City of Santa Fe, New Mexico

memo

2026-012491-HDRB. 511 Paseo de Peralta. Downtown & Eastside Historic District. Marisol Ortiz, agent for Peralta's Walk LLC, owner, proposes to construct a 6,212 sq. ft. multi-family residence to a height of 27'-6", where the maximum allowable height is 23'-0" on a sloping vacant lot.

Figure 3: Proposed Site Plan

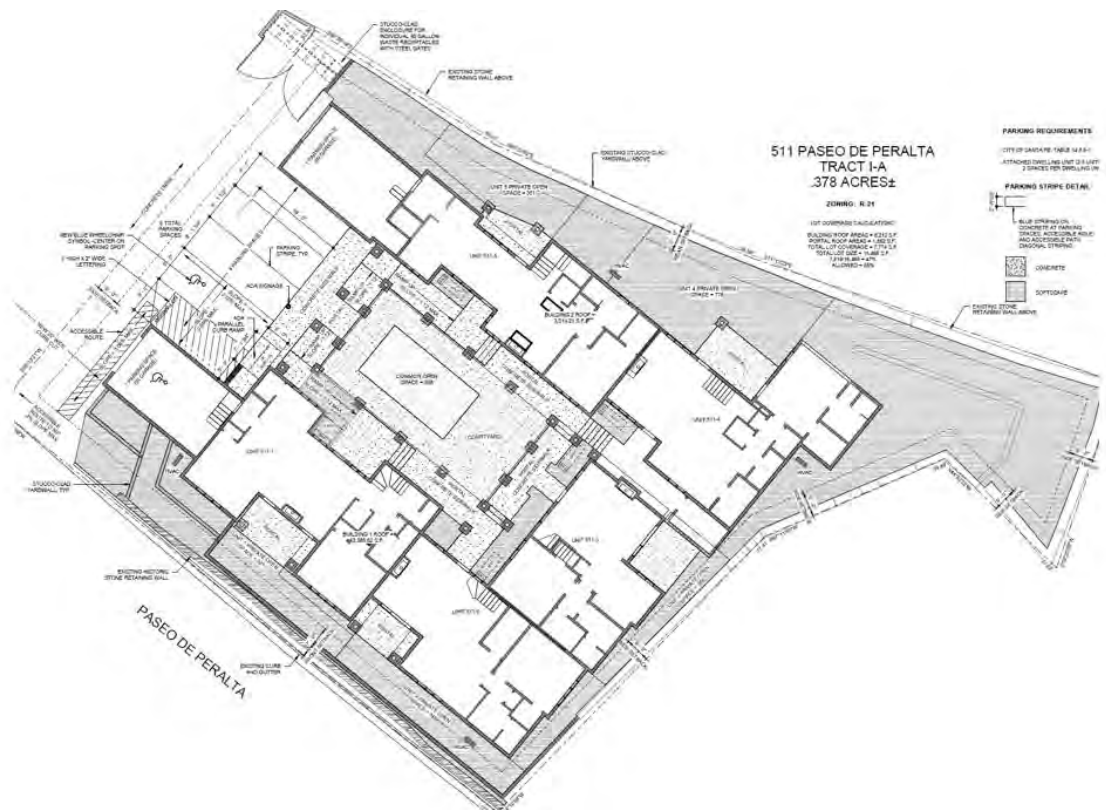
- 1) Construct a 6,212 sq. ft. multi-family residence to a height of 27’-6” where the maximum allowable height is 23’-0” on a sloping vacant lot. All buildings are of Pueblo Revival design with earth-toned stucco finishes designed with flat roofs and parapets. Each building uses a variety of setbacks and offsets to break up the massing. The proposed project includes 5 condominiums in a two-story building. The tract is zoned R-21, which allows for multiple units on the lot. The tract has an approved 2023 Development Plan with the city, which matches this request. Detail finishes include stone caps on chimneys and metal fascia, columns, roofing, and railing. Windows are wood-clad. Yard walls, to a height of 6’-0”, will define the private open spaces behind the existing historic stone wall. The existing historic stone wall will remain with no modifications.

Staff recommends approval of the proposed project and finds that the application complies with Section 14-4.6(E) General Design Standards for all Historic Districts and 14-4.6(G)(2) Downtown and Eastside Design Standards.

Figure 4: Proposed North Elevation

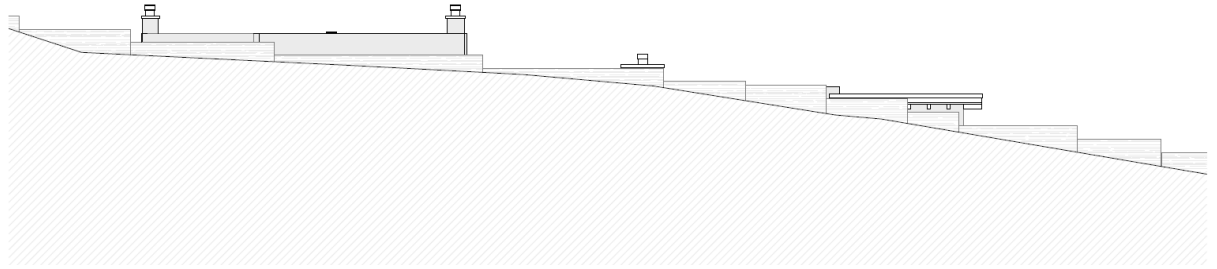
1. Unit 1, remove the window in the Office looking directly to the portal.
2. Unit 2, remove the door under the portal that directly accesses the Kitchen.
3. Unit 3, under the portal, change the single door and double window to a double door and a single window.
4. Unit 4, under the portal, change the single door and single window to a single door.
5. Unit 5, in the Dining room, decrease the window from size from three windows to a double window.

1. Unit 1, at Bed 1, change the single door and double windows to double doors on the north and south elevations accessing the decks.
2. Unit 2, in Bed, change from triple windows to double doors accessing the deck.
3. Unit 4, Bed 2, remove the door on the north elevation to the non-existent overhang.
